Re: *FAA Initiative Phase 1*, SFO Airport/Community Roundtable Response

SFO AIRPORT/COMMUNITY ROUNDTABLE RESPONSE TO FAA INITIATIVE

TECHNICAL DISCUSSION PACKAGE SFO AIRPORT/COMMUNITY ROUNDTABLE RESPONSE TO FAA INITIATIVE

SFO ROUNDTABLE RESPONSE TO FAA FEASIBILITY REPORT

PROCEDURE: Visual Arrivals, Foster City Arrivals	ADJUSTMENTS: 1.b.iii., 1.b.iv., 1.b.v.
---	---

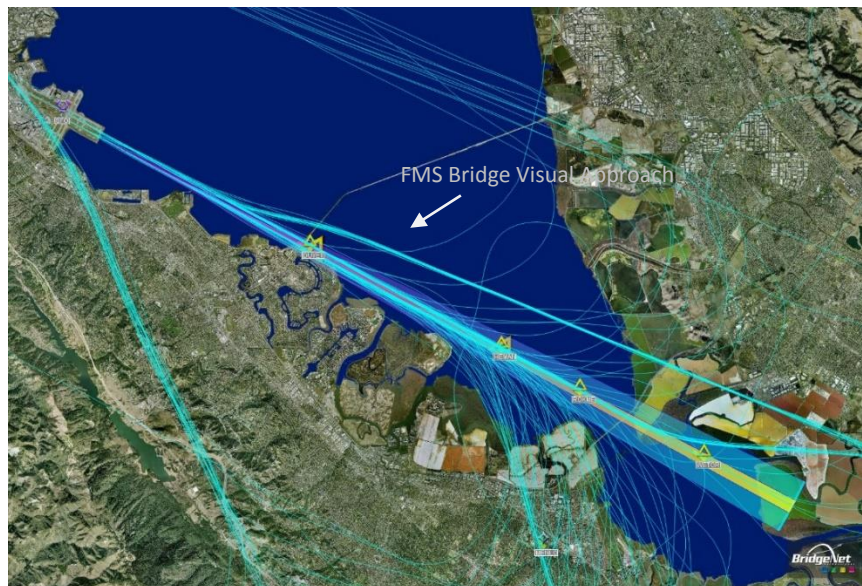
1. The SFO Roundtable will work with NCT management to illustrate the importance of the use of Runway 28R instead of Runway 28L during periods of single stream operations and the critical nature of nighttime operations which might require managing arrival traffic to create a single stream of traffic to 28R.
2. The SFO Roundtable will provide information and community input to the FAA regarding the process of creating, if feasible, of dual satellite-based Runway 28L and 28R offset approaches closer to the middle of the Bay.

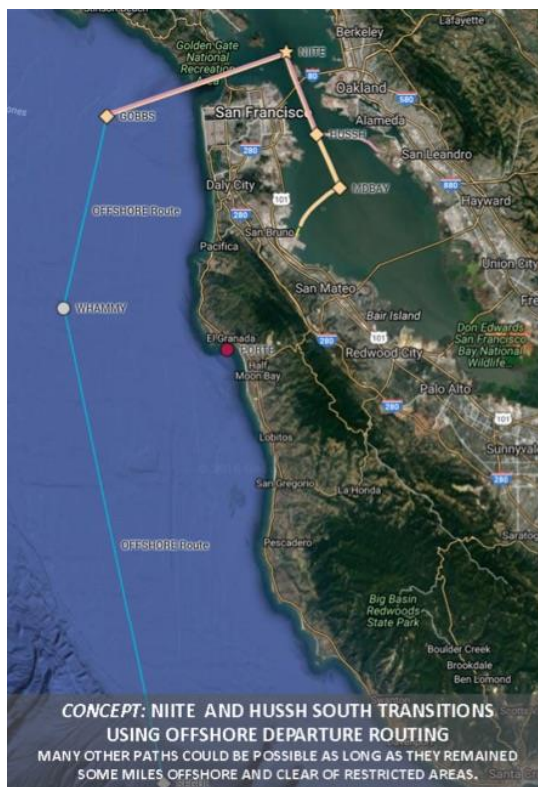
1. **Southbound Transition:** While undergoing the formal process of amending the NIITE departure to add a transition for southbound aircraft past GOBBS and adopting GOBBS for use, the Roundtable requests that NORCAL TRACON work with the SFO RT to determine if an interim informal procedure based on TRACON vectors might be feasible during the nighttime hours only to approximate the NIITE departure which would be heading up the Bay to NIITE, then west to GOBBS, then south-south-east to the PORTE or WAMMY waypoint, remaining clear of the shore. While the Roundtable is asking for the NIITE procedure to be used, it is not requesting increased use of Runway 01 L/R for departures, especially at night.

1. NIITE Southbound Transition: The SFO Roundtable is in agreement with FAA *Initiative* Adjustment 2.f.i and formally requests that the FAA add a transition to the NIITE departure for southbound aircraft.

Without presuming to technically design such a south transition, it would seem that this highly desirable southbound destination transition *might* be comprised of a single, simple “add-on” leg, using the existing NIITE departure to the GOBBS waypoint, and thence via already largely existing waypoints and flight paths mirroring much of the PORTE departure to PORTE intersection. In addition, the routing of the OFFSHORE departure may present an additional option using the WAMMY waypoint. The SFO Roundtable understands that the design of professional flight procedures encompasses far more than a line drawn on a

The possible southbound transition for the NIITE departure depicted above contains just two concepts to consider. The “add-on” paths depicted seem desirable not only because they keep aircraft largely over the Pacific Ocean, but also because a significant portion of the “add-on” paths are routinely used in the PORTE and OFFSHORE departures. Many other paths for this southbound transition could be designed that would also keep aircraft over the ocean.

NIITE Southbound Transition & NIITE Departure with Runway 10 takeoffs authorized:

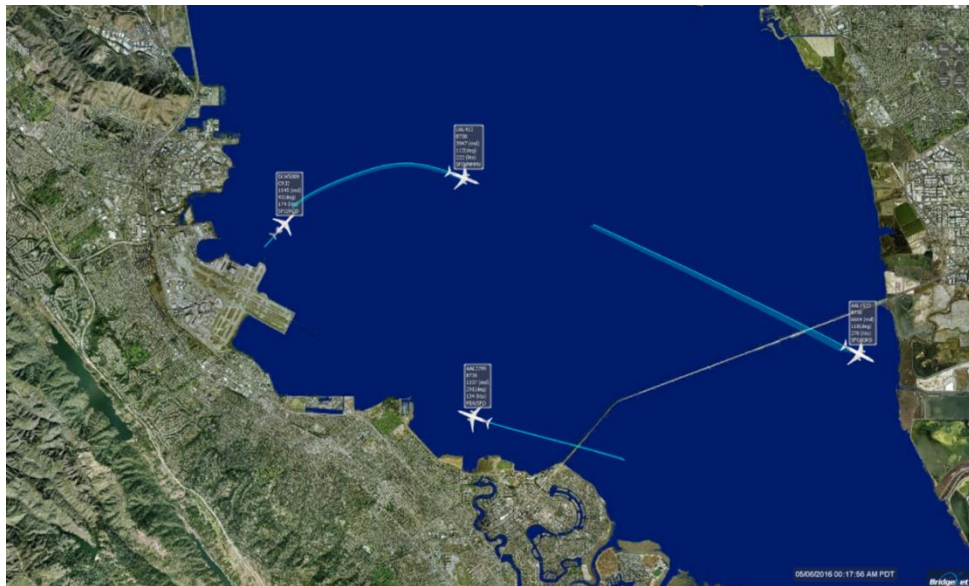
1. The SFO Roundtable will provide input regarding the new southbound transition and will elicit community input and response to the design of the new NIITE southbound transition and Runway 10 L/R NIITE authorization.

SSTIK
Departure, SFO and CNDEL Departures, OAK

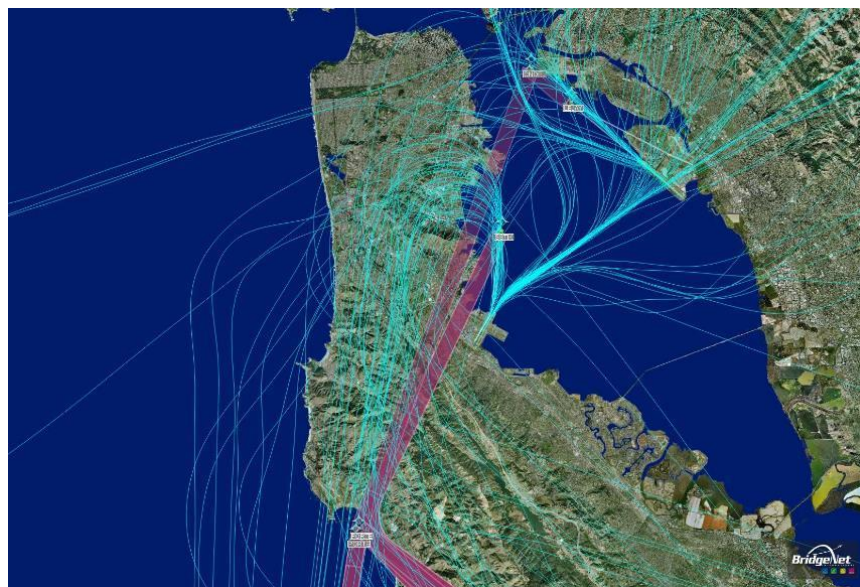
4. Create a SSTIK transition to GOBBS. Similar to the NIITE procedure, aircraft would depart on the SSTIK procedure flying up the Bay instead of over the peninsula to approximately the GOBBS intersection, then onto a waypoint in the ocean such as WAMMY. This could be used for aircraft with southerly destinations in California. This would be the preferred long term solution as it would greatly reduce negative noise impacts because planes would be flying over water, rather than directly over people's homes.

1. The SFO Roundtable will provide community input to the FAA to find an appropriate location for moving the SSTIK waypoint east and north of its current location, again using SEPDY as a guide, so planes can fly over the Bay for a longer period of time, and thus increase altitude before heading west and flying over residential areas.
2. Request the FAA provide modeling, noise monitoring, and/or other tools to determine the effects of different waypoint options.

3. The SFO Roundtable requests the FAA to allow planes to fly the charted procedures and to reduce vectoring and when safety is not an issue as well as to use higher altitudes when flying over noise-sensitive land uses and the use of non-residential areas where feasible.
4. The SFO Roundtable will work with the SFO noise office and TRACON to research use of the legacy LINDEN VORTAC transition to determine why it has not been used within the last few years and determine which city pairs can utilize this corridor via TIPRE or SYRAH.
